REMOVING THE EARTHING PIN FROM THE REAR CASING ASSEMBLY

EN Publication number 599 72 70-45	Rev. 00	02/2009	dmm
------------------------------------	---------	---------	-----

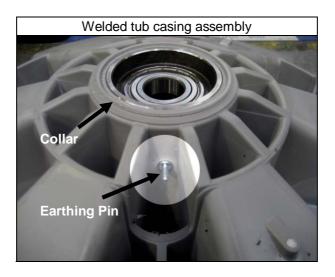
From Serial Number 950 xxxxx in all the rear casing assemblies, a collar has been created in the area around the hub and the earthing pin has been eliminated. As a result of this:

• the relevant wiring is removed and the plastic pulley is used.

The rear casing assembly, complete with collar and earthing pin, is supplied as a spare part and can be used on all appliances, as shown in the diagram provided on the table in the paragraph "service information".
